DETAILED COMMENTS ON APPLICATION NUMBER: 2012/5825/P part 1

**DETAILED REPORT OF OBJECTIONS TO PLANNING APPLICATION
2012/5825/P**

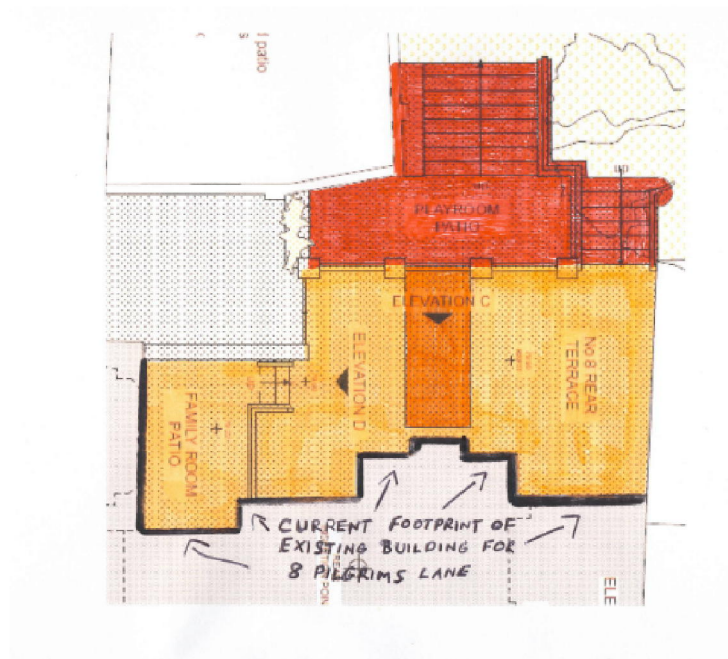
This report is erroneous:

. Point 10.2 (“the proposed basement will not extend beyond the foot print of the house”) of the report is blatantly false. The proposed basement extension will extend substantially beyond the footprint of the existing house on several counts such as:

Basement extension beyond existing footprint (all coloured areas)

.For one, the applicant introduces a separate elevation 4.1 m from the foot print of the house complete with playroom patio and two steps.

.Second, the basement extends 4.1 metres from the foot print of the house with a proposed playroom under the terrace.2b

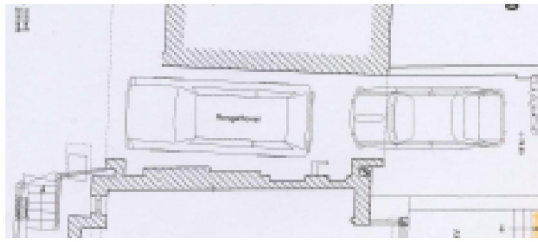
We notice that in the proposed ground floor plan, a car would be constantly in front of the property and every time we would open our entrance door we would be facing it within 2 metres and we do not want this. Furthermore, it would create a negative aspect on our property and that of the neighbours.

Ref: 6 previous car port drawing

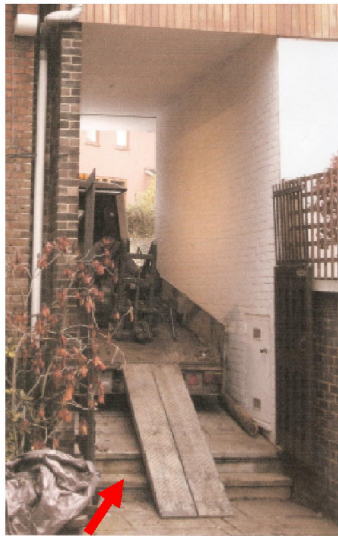
Furthermore the narrow driveway is not conducive to the traffic of cars and especially of large cars as the applicant intend to do as shown in drawing 6 below . Proof is that the new owner has already damaged the column located in the driveway that supports my living room. The statement in the Delegated Report related to the previous application is not factual: the parking space proposed in the patio would not formalize the existing situation; the existing staircase below the timber gate in the driveway proves that the space located further south was not designed and used for parking up until now. One can also see these stairs in photograph 6, page 4, of the BIA.
